Upper South Creek

Advanced Water Recycling Centre and Pipelines

Surface Water & Groundwater CEMP Sub-Plan

Subject: Environmental Representative (ER) review and approval – Revised Surface Water and Groundwater CEMP Sub-plan, Revision E

CoA C6(b)

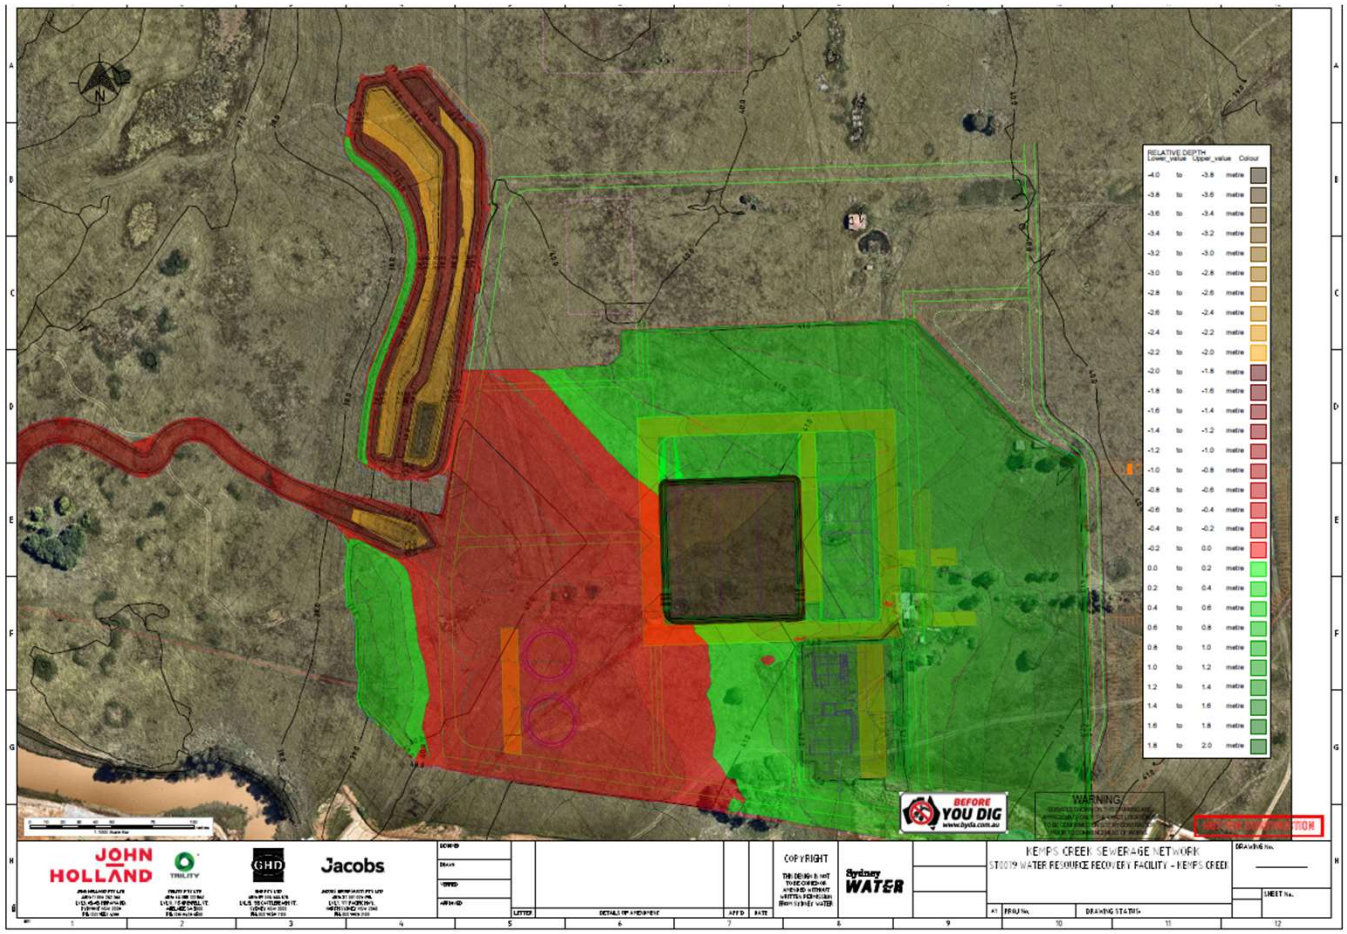
EHG Comment:
Final contours are not shown. This is required in order to understand how earthworks levels will change and influence controls as earthworks progress. Additional plans should be provided.
